DA2025/006

12 JUBILEE AVENUE, BRIGHTON

### **MULTIPLE DWELLINGS X 13 (12 NEW & 1 EXISTING)**

# APPLICATION FOR PLANNING PERMIT (DA 2025 / 00006) MULTIPLE DWELLINGS X 13 (12 NEW AND 1 EXISTING), 12 JUBILEE AVENUE, BRIGHTON

ROJECT: UNIT DEVELOPMENT	ADDRESS:	12 JUBILEE AVENUE BRIGHTON	SHEET:	COVER		
	CLIENT:	CREATIVE HOMES	SCALE:	AS INDICATED	TOTAL SHEETS: 14	SIZE: A1
			PROJECT No	24E35-24	SHEET: C001	REV: C

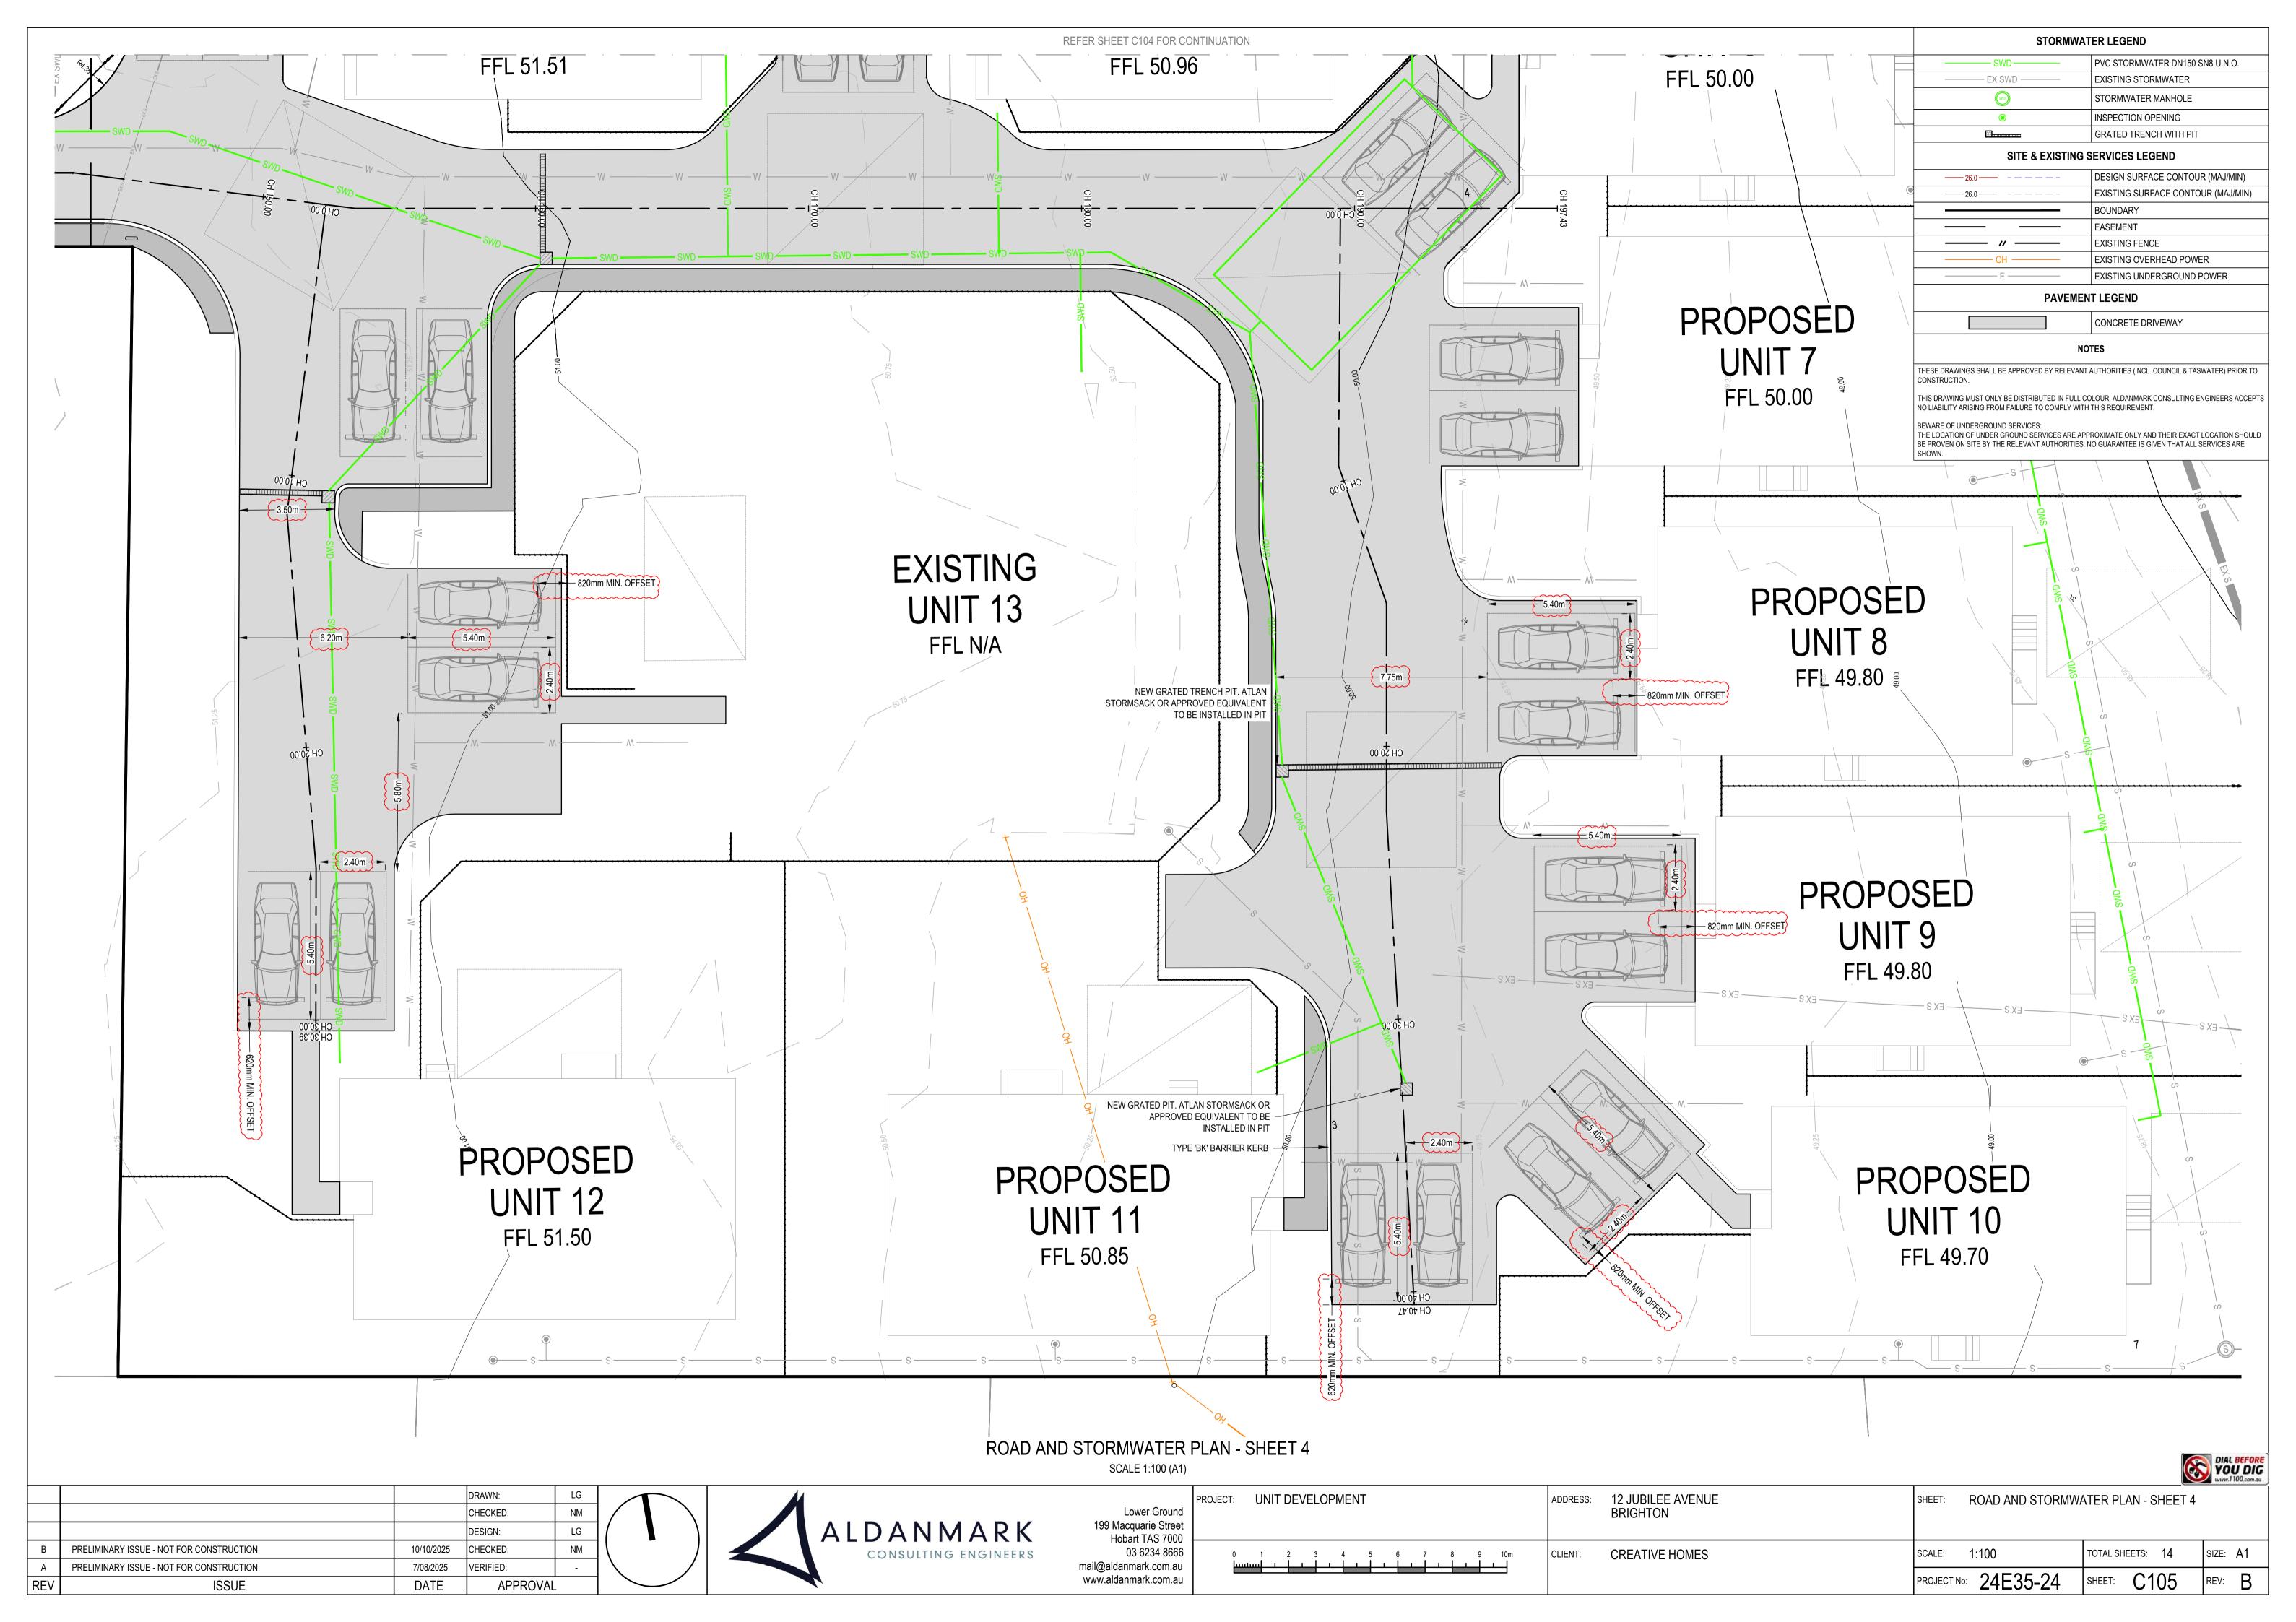
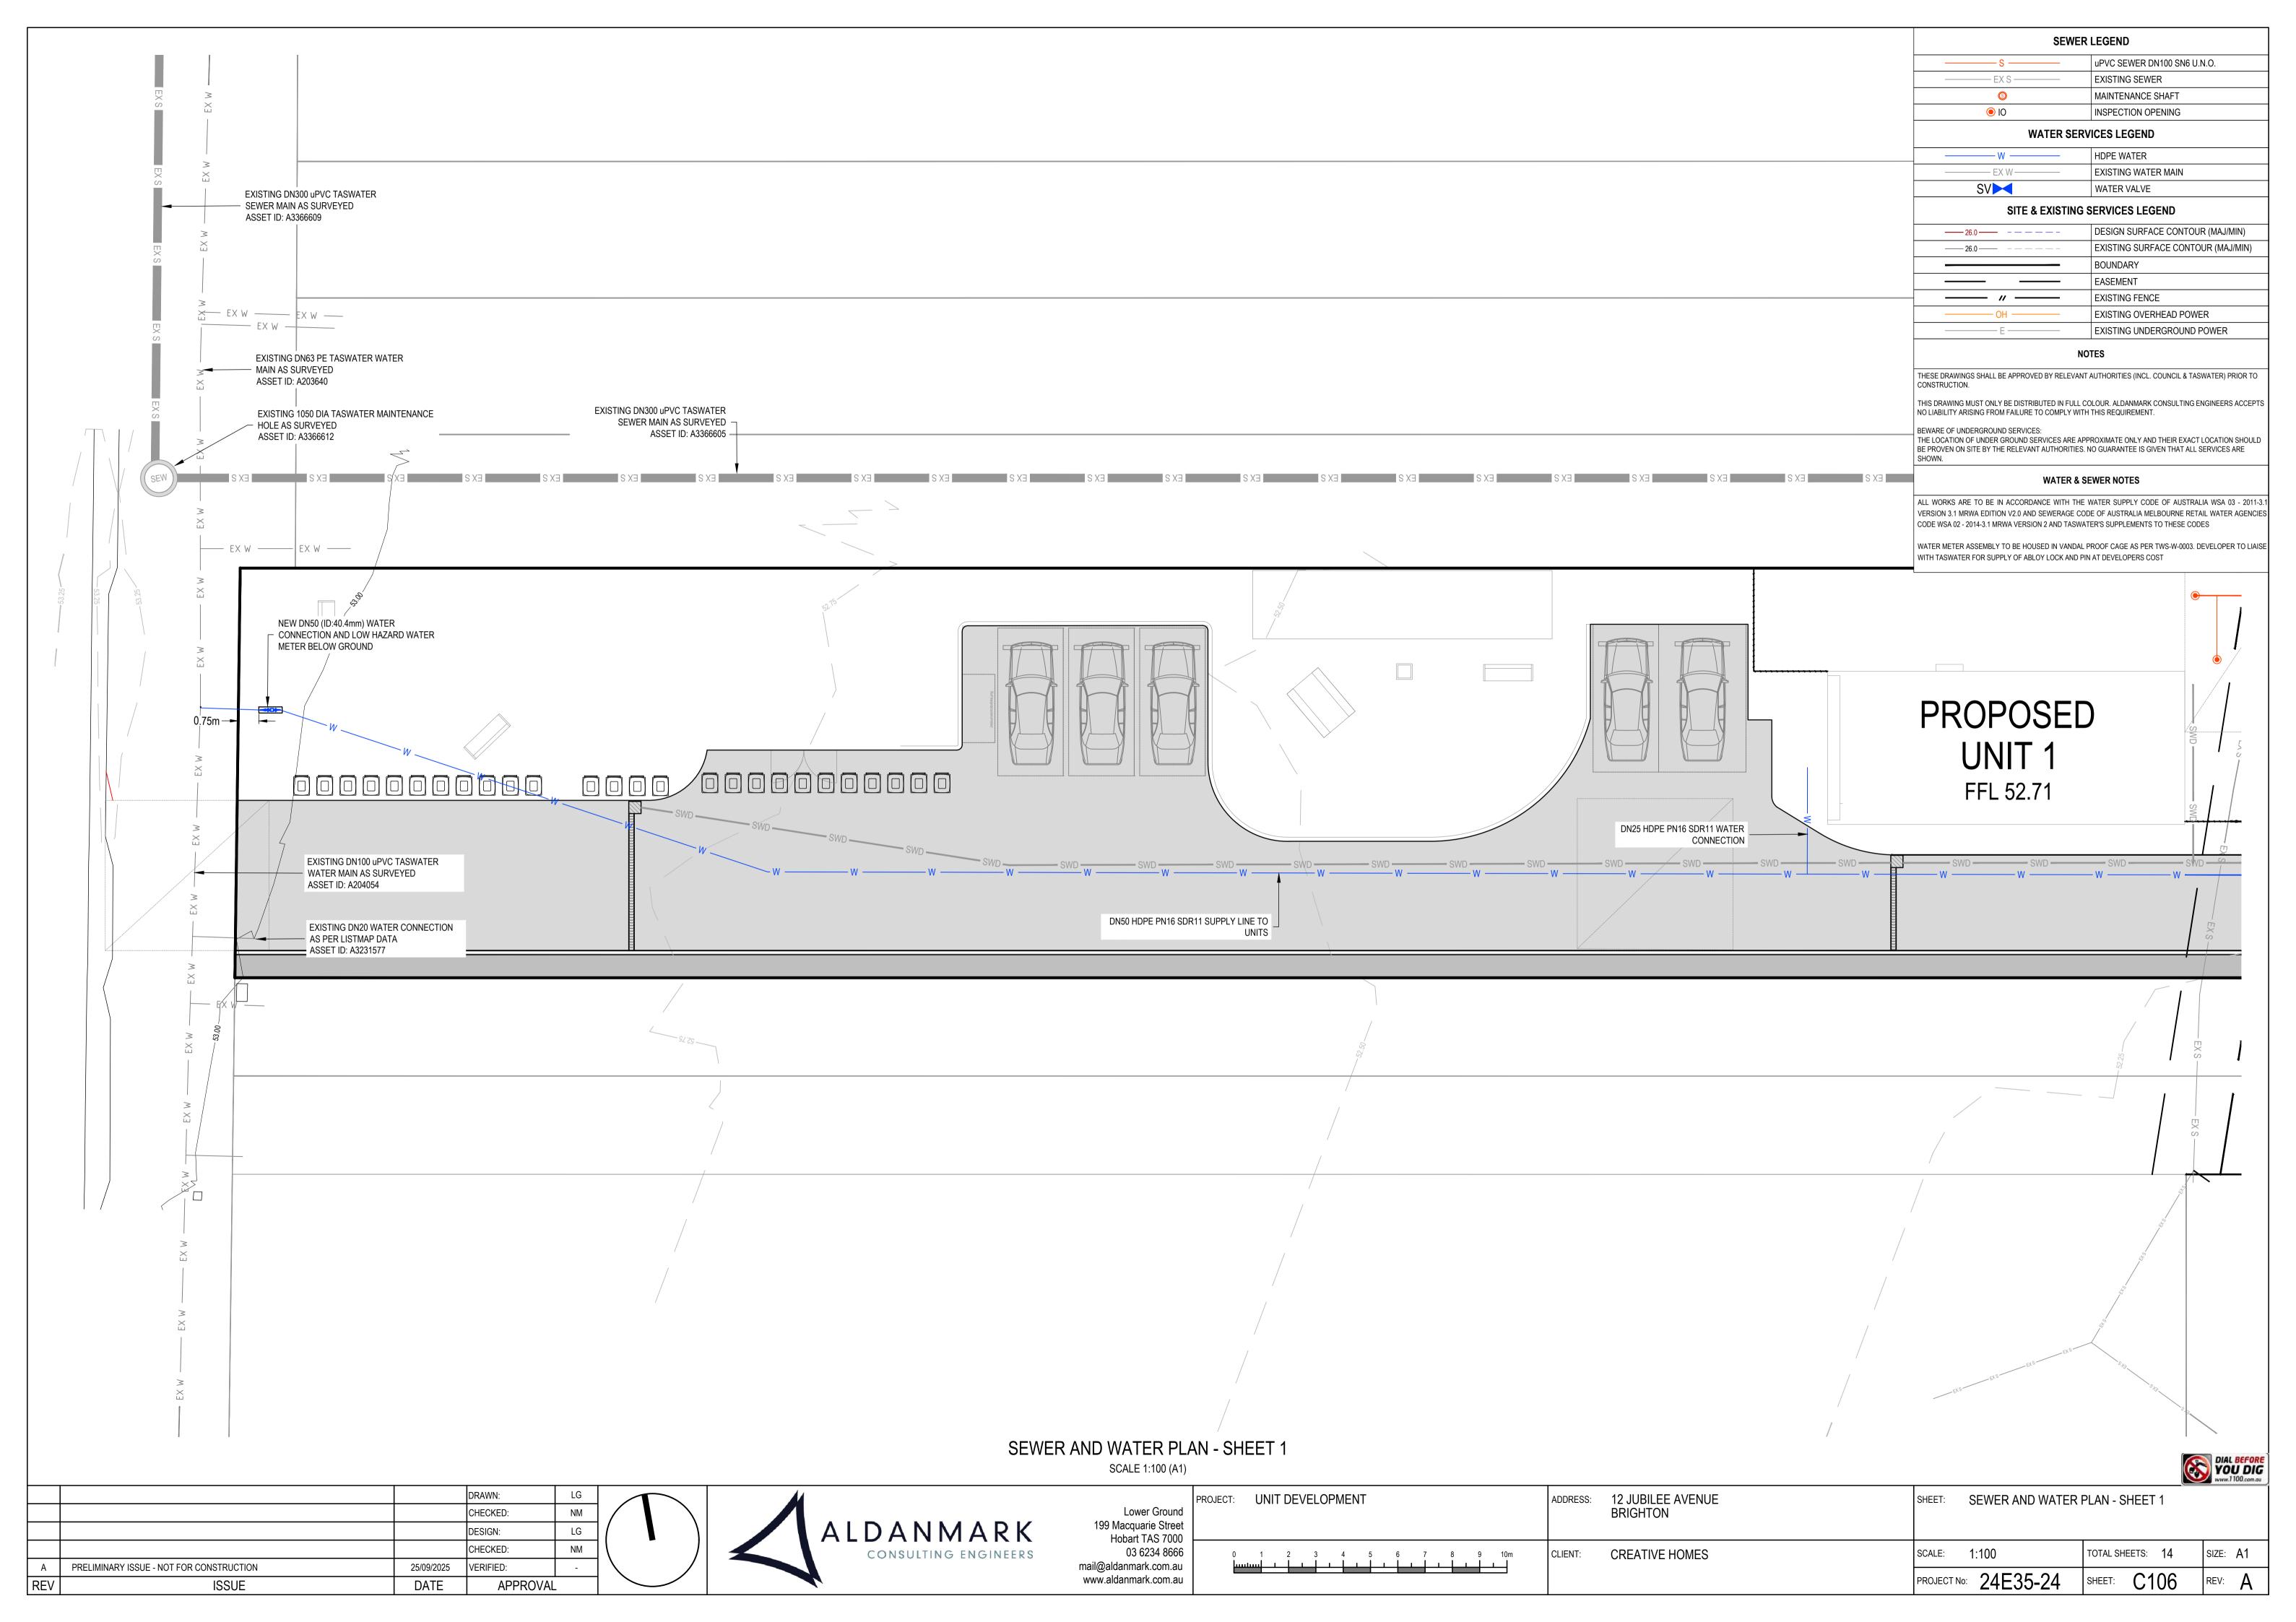
RFI CONDITION	COMMENTS	AMENDMENTS	ALDANMARK DRG REFERENCE	
4(a)	Provide a revised plan set that addresses C2.6.2 A1.1 (iii) in particular providing a 5.5m carriage way throughout or provides passing bays that include workable tapers and are orientated to accommodate the flow of traffic. Turning sweeps should be shown at each passing bay.  Adequate tapers have been provided for all passing bays, are oriented to the flow of traffic and have turning paths shown as per Sheets C110 – C113 RevB			
4(b)	Provide a revised plan set that addresses C2.6.2 A1.1 (v) provide parking bays throughout that meet the requirements of Table C2.3 including which do not encroach upon pedestrian access ways.	No parking bays are shown encroaching on pedestrian access ways.	C110 – C113 RevB	
4(c)	In accordance with 2.6.5 A1.1 parts (a) and (b) including with a pedestrian throughfare that has a surface raised 150mm above that of the roadway and is not encroached with vehicle reversing.	Type 'BK' Barrier Kerb as per LGAT drawing TSD-R14-v3 has been noted on Sheets C102 - C105 RevB. Footpaths match into the back of 150mm high kerb. Aisle widths from the carpark to the kerb have been shown on Sheets C102 - C105 RevB for all car parks and are above the minimum requirement of 5.8m for User Class 1A as per AS2890.1. This allows for adequate space for reversing without encroaching, as deemed by AS2890.1	C102 - C105 RevB

N/a	Council comment regarding Unit 4 passing bay:  Picture above of the internal intersection change of direction occurring at unit 4 that has not been taken into account if a vehicle wishes to turn left entering from the right. Proof or an understanding of this action is required.	Aldanmark considers the vehicle entering from the right and turning left at the intersection outside of Unit 4 an improbable scenario. Only vehicles accessing the existing dwelling and the proposed Unit 12 will enter this section of the driveway, which would be from the left of page. This intersection is the widest	C113 RevB

part of the driveway which has sufficient space for turning and an adequate carriageway width of 3.5m has been provided at the exit to the existing dwelling and proposed Unit 12.	
12	It is noted that 16 Creed Court currently provides overhead power supply to 12 Jubilee Avenue via	This is not Aldanmark's decision. Creative Homes to address.	N/a
	a private pole. Please confirm whether this existing overhead supply will be removed and replaced with an underground connection.

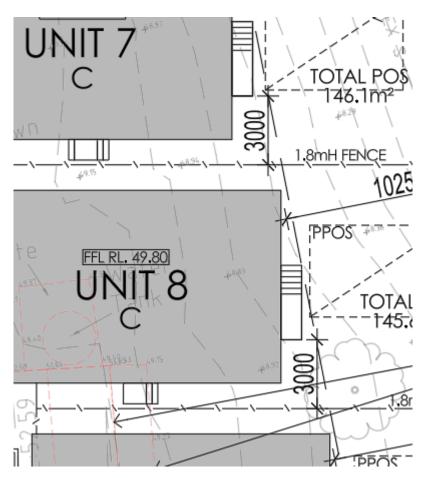
1. Provide a site plan/elevation plan showing the compliance of Clause 8.4.6 A1(c) for Unit 8

Advice: U8 seems to have a deck that has a finished floor level of 1m higher than existing ground level.

Units 6 – 10 decks have been amended to ensure the position is a minimum of 3m from the fence separating the units in order to facilitate the maintaining of privacy through the prevention of overlooking. Additional dimensions have been added to demonstrate this.

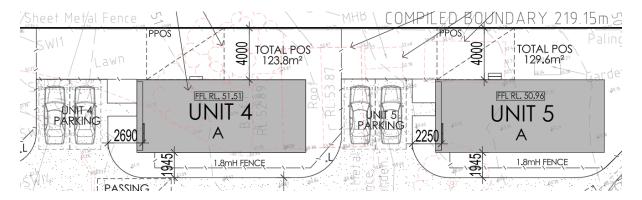
2. Provide a site plan/elevation plan showing the compliance of Clause 8.4.6 A3 for Units 4 and 5

Advice: U4 & U5 front windows have a distance of less than 2.5m to the shared driveway and have no proposed screening or to be obscured.

The front lounge room windows to unit 4 & 5 do not face a shared driveway – they face an area of designated parking for the exclusive use of that unit. Therefore since it is not a shared space, screening or obscuring of windows is not required.

## See below for dimensions

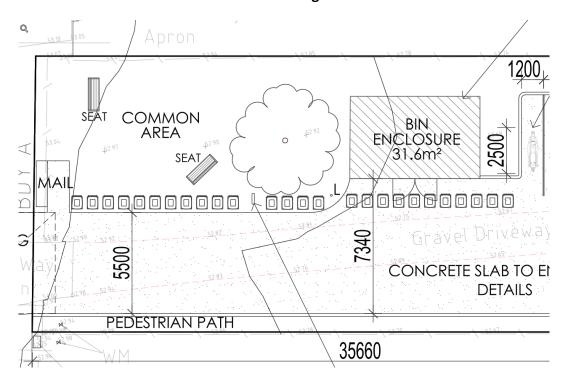
5. Provide further details for the safe passage of pedestrians within the complex across the internal driveway including level changes encountered.

"The development will require pedestrians to cross the driveway at certain locations, at each location suitable sight lines will be available."

"Where possible barrier kerb will be used to separate the pathway from the driveway, similar to urban streets, where this treatment is considered appropriate. Number of vehicle and pedestrian movements within the development is expected to be low, generating a low conflict risk."

"A 10 km/h shared speed limit will be installed at the beginning of the site, to moderate the operating speed of vehicles."

"Where the pathway crosses the internal road, it will be delineated with road markings, defining the pathway and pedestrian crossing areas" in accordance with AS 1742.2 which provides detailed guidelines for the design, installation, and maintenance of road line markings in urban areas, including dimensions, colours, and placement of markings.
